**From:** Craig, Jack [Jack.Craig@lm.doe.gov]  
**Sent:** Thursday, November 19, 2009 8:01 AM  
**To:** Stanczyk, Jane  
**Cc:** Hutton, Rick  
**Subject:** Noble APDs - Rulison

**From:** Stanczyk, Jane  
**Sent:** Tuesday, November 17, 2009 9:01 AM  
**To:** 'Rick Hutton'; 'Craig, Jack'  
**Cc:** Neslin, David; Willis, Rob; Ahlstrand, Dennis; Yokley, Bill; Andrews, David; Krabacher, Jay; King, Kevin; Halstead, Mary; Kubeczko, Dave; Fischer, Alex; Canfield, Chris; Baldwin, Debbie; 'Kate Fay'; 'luke@danielsonlaw.com'  
**Subject:** Noble permits in Project Rulison NESE Sec 19 7S 94W  
**Attachments:** Project Rulison NOBLE APDs Sec 19 11-17-09.xls

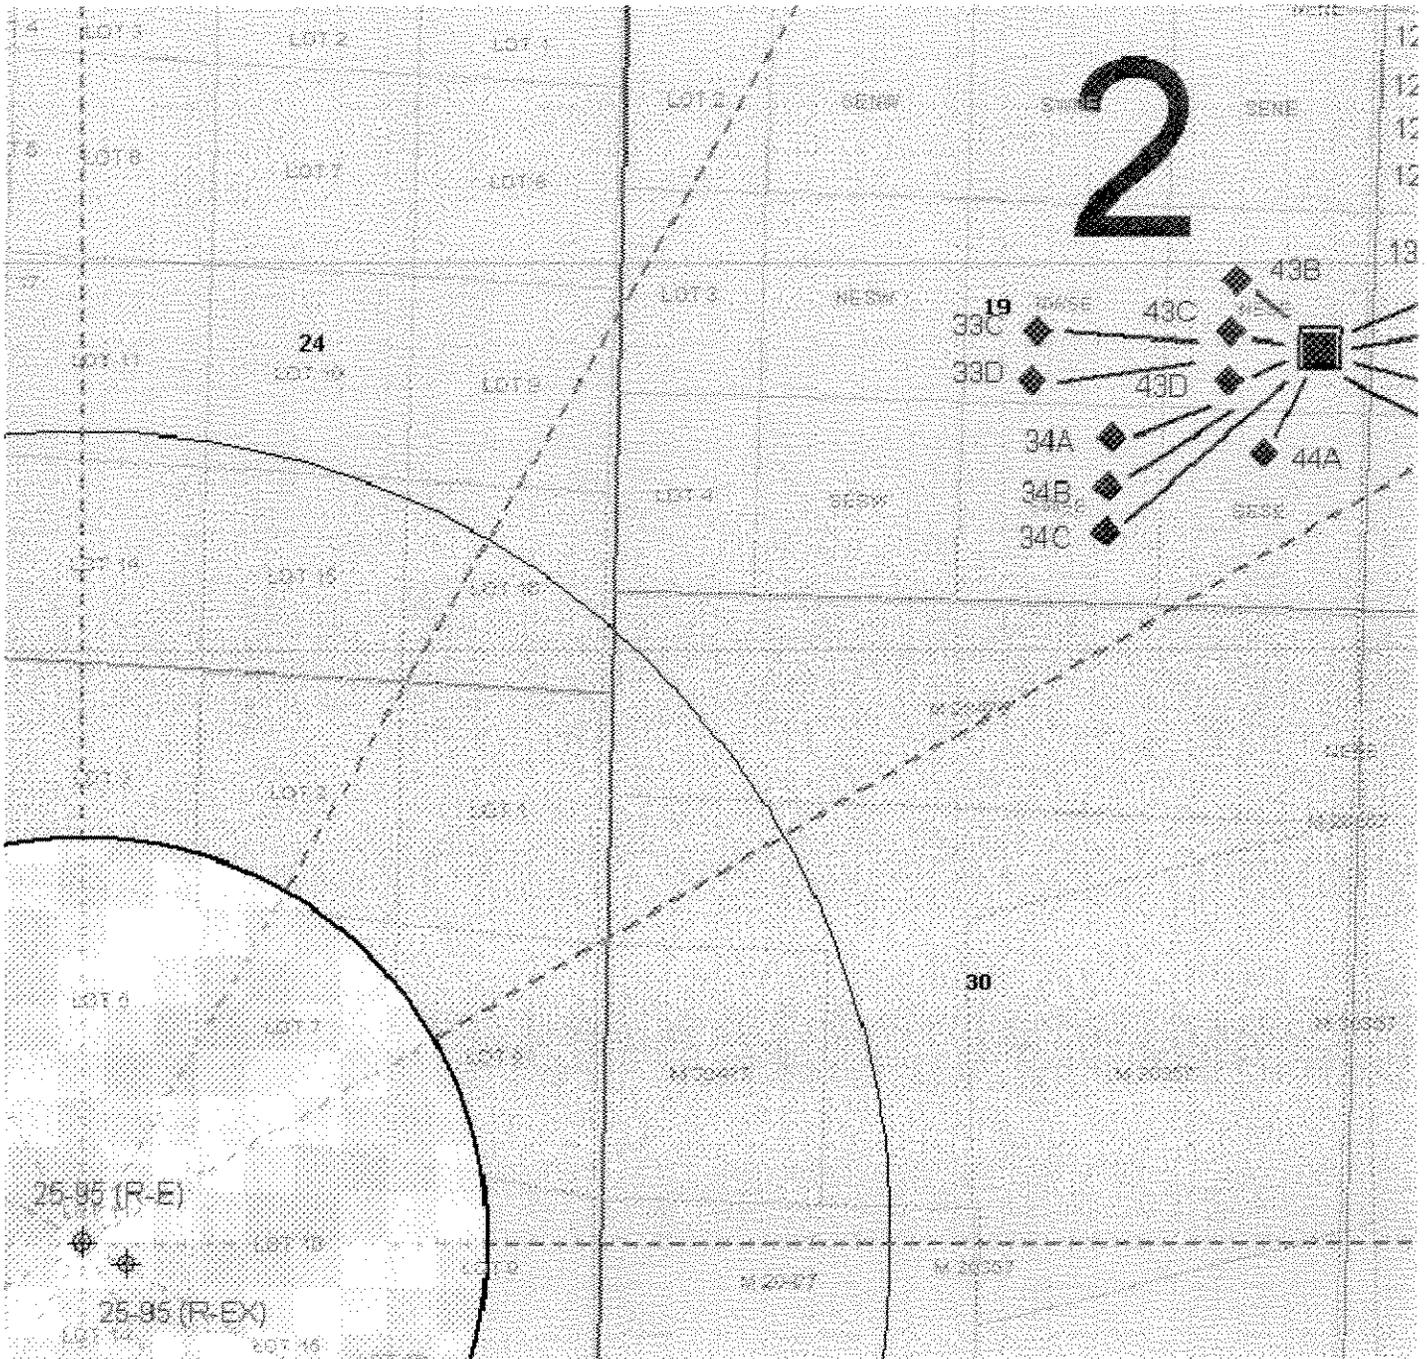
Noble has submitted permits for a new pad in the Project Rulison 3 mile area.

The surface location is in the NESE Section 19 7S 94W, approximately 1.9 miles from the project well.

There are permits for 13 wells with bottom hole locations in Sections 19 and 20 7S 94W, approximately 1.5 to 2.1 miles from the project well.

All the wells are in Tier 2 of the Project Rulison Sampling and Analysis Plan.

Twelve (12) of the wells are in Sector 2 and one well, the 20-14A is very close to the line between Sectors 2 & 3.

At this time, DOE does not request any additional information but would encourage COGCC to place general language in the permit such that the company would accommodate DOE sampling requests in the future. DOE agrees with the COGCC assessment that the pad is located approximately

1.9 miles from the Rulison site at the NESE of Section 19 7S 94W, and the bottom-hole-locations range approximately from 1.5 to 2.1 miles from Project Rulison. Accordingly, DOE agrees with COGCC that all wells fall under the Tier 2 sampling and monitoring of the COGCC Rulison Sample and Analysis Plan and are located in Sector 2 or 3 of the Rulison SAP. DOE will continue to review the proposed locations and subsurface orientations of the propose drilling for documentation when sampling occurs. Thank you for the opportunity to comment on these permit applications. Please e-mail or call at 240-252-8506 if you require further information.
